Addendum 127 – Regulation No. 128

Amendment 2

Supplement 2 to the original version of the Regulation – Date of entry into force: 10 June 2014

Uniform provisions concerning the approval of light emitting diode (LED) light sources for use in approved lamp units on power-driven vehicles and their trailers

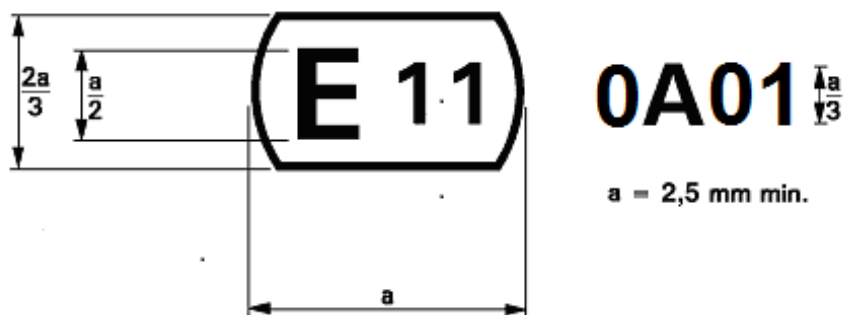
Paragraph 2.4.2., amend to read:

"2.4.2. ...

This will be followed by an identification code comprising not more than three characters. Only the following Arabic numerals and capital letters shall be used:

- "0 1 2 3 4 5 6 7 8 9 A B C D E F G H J K L M N P R S T U V W X Y Z"
- ..."
